| Subject: RATTLE NOISE FROM FRONT DOOR GLASS | Bulletin No: 09-041/16 |
| | Last Issued: 06/24/2016 |

2013-2016 CX-5

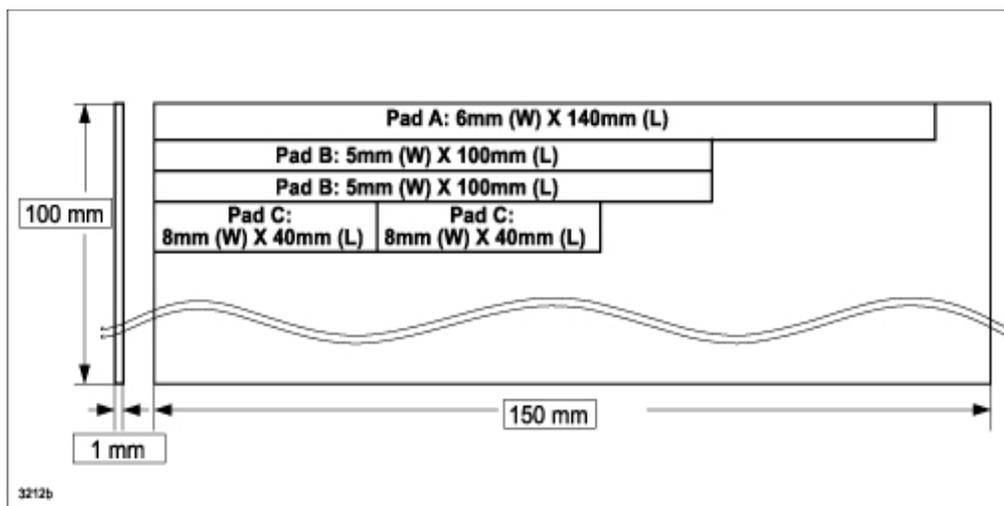
The rattle noise may be caused by insufficient holding force of the glass run channel. To increase the holding force, the shape of glass run channel has been changed and non-woven pads have been attached to the glass run channel.

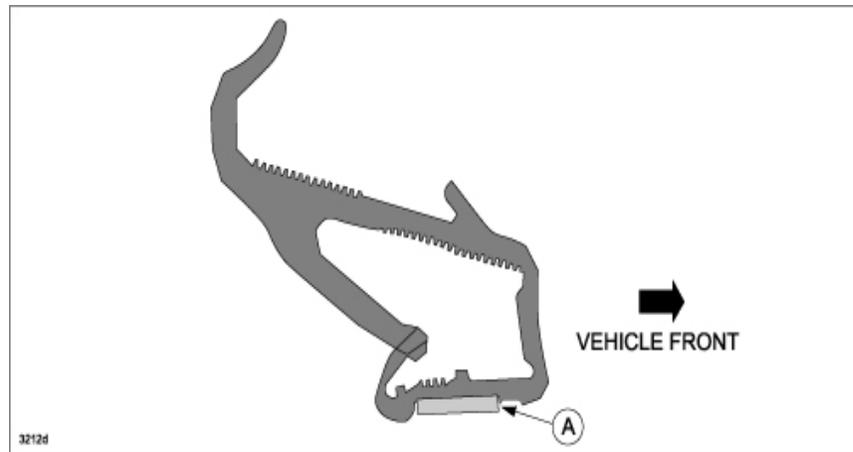
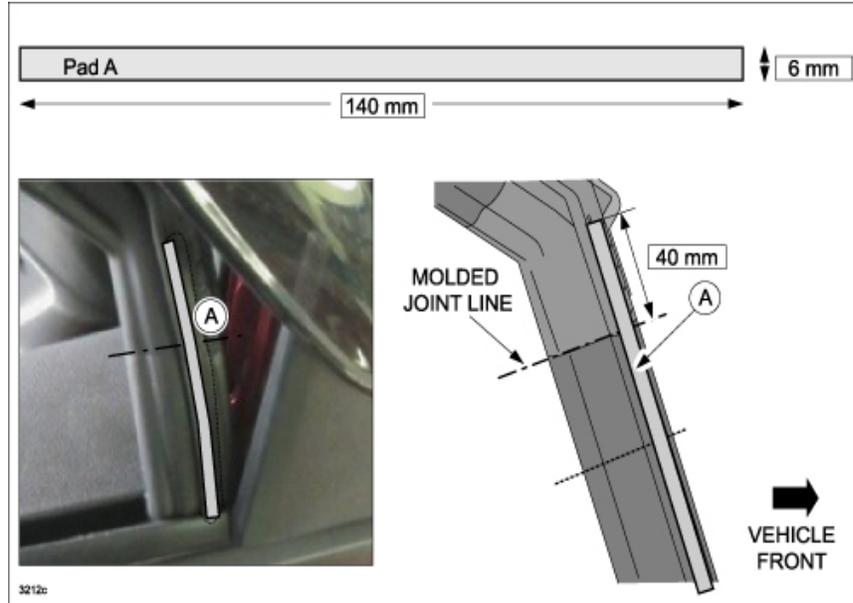
- ATTACH PAD A:** Attach Pad A (6mm x 140mm x 1mm) to the position on the new glass run channel, as shown below.

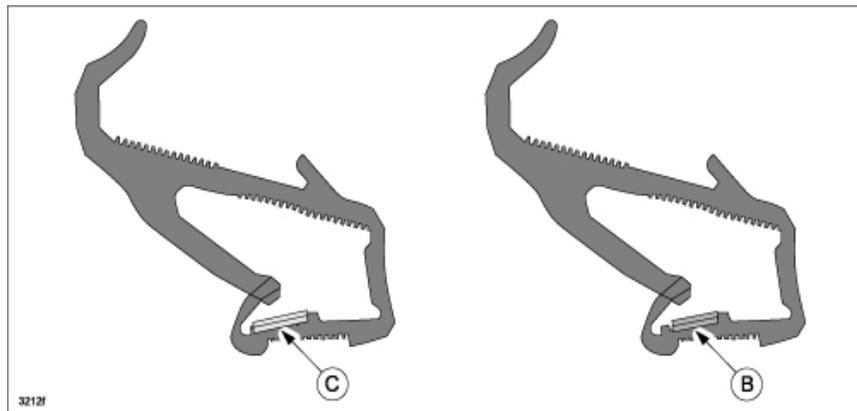
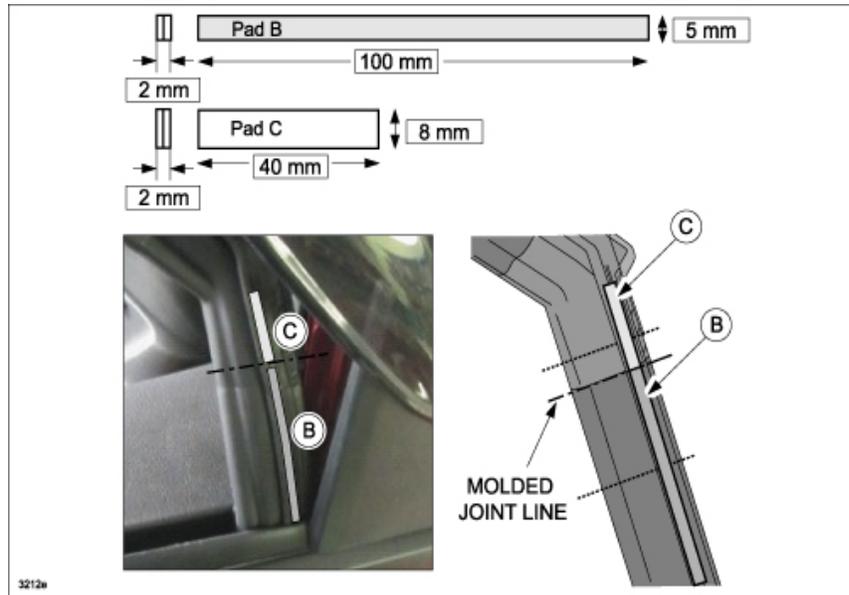
7. **ATTACH PADS B AND C:** Attach Pad B (5mm x 100mm x 2mm) and Pad C (8mm x 40mm x 2mm) to the correct positions on the new glass run channel, as shown below.

NOTE: Stack two pieces (B + B and C + C) together to get 2mm thickness.
